## **APPENDIX 5    KEY CORRESPONDENCES**

**RE: Russell Vale Colliery Underground Expansion Project  
Public Hearing, Addendum Report & Draft Project Approval**

**WOLLONGONG COAL RUSSELL VALE COLLIERY  
PREFERRED UNDERGROUND EXPANSION PROJECT NO. MP 09\_0013**

**Figure 1 RV20 Pressure Head vs Depth Profile**

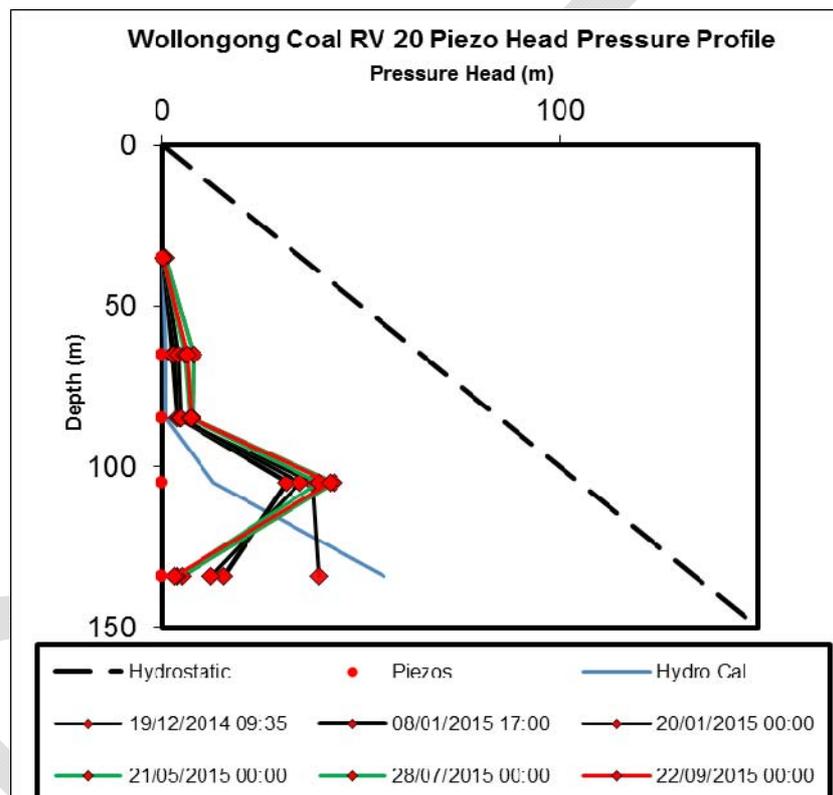
**Q11 - How does the pressure profile indicate enhancement and what is the enhanced vertical flow?**

A11 – RV20 is a borehole located over Longwall 4 in an area where triple seam mining has caused significant strata fracturing, delamination and associated groundwater depressurisation. The head vs depth pressure profile of the piezometric array shown below indicates that all the strata from 35 – 65m below surface in the Hawkesbury Sandstone and then from 65- 85 m in the Bald Hill Claystone is highly depressurised. There is evidence of a head pressure rise at 105 mbgl in the top of the Bulgo Sandstone. However, the piezometer at 134 mbgl in the Bulgo Sandstone is depressurised as shown in **Figure 1**.

The enhanced vertical flow rate, in terms of hydraulic conductivity, has not been directly measured, however the quantum of inflow into the underground workings is separated into inflows into Longwalls 4 and 5 and these inflows are consistent with downward flow through the overburden strata via a tortuous fracture network. The non-hydrostatic nature of the piezometric profile indicates the tortuous / discontinuous nature of the fracture network.
